ISO/IEC/
IEEE
8802-1Q

AMENDMENT 6
2019-02

**AMENDMENT 6: Per-stream filtering and
policing**

Amendment 28: Per-Stream Filtering and Policing

Figure 8-11—Forwarding process functions

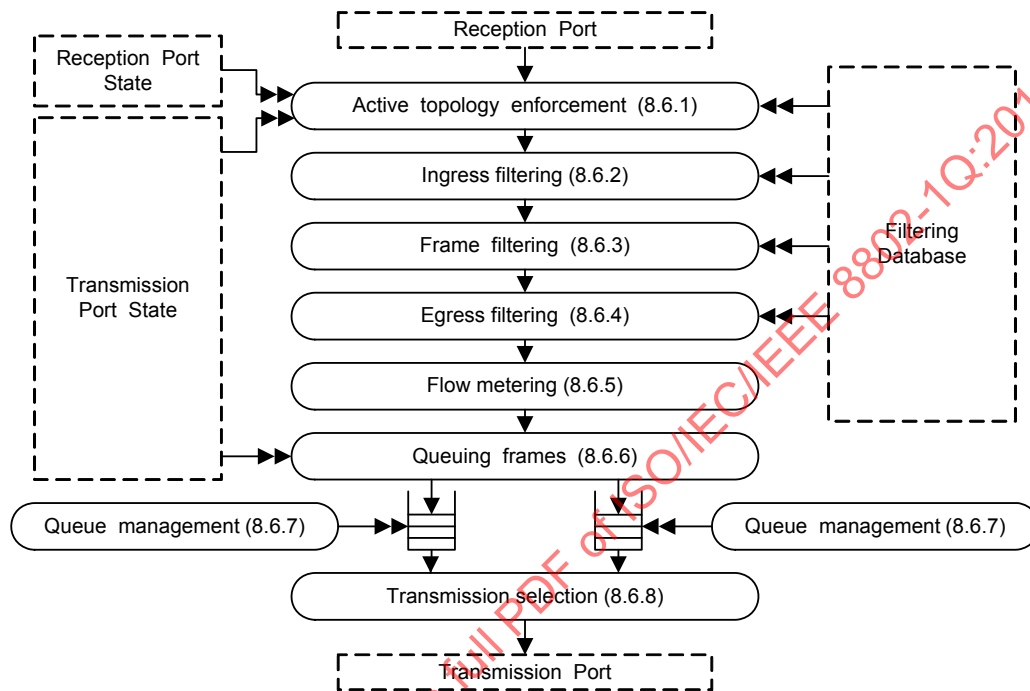
Replace Figure 8-11 with the following figure. The effect of this replacement is to change “Ingress (8.6.2)” to “Ingress filtering (8.6.2)” and “Egress (8.6.4)” to “Egress filtering (8.6.4)” to match the subclause headings.
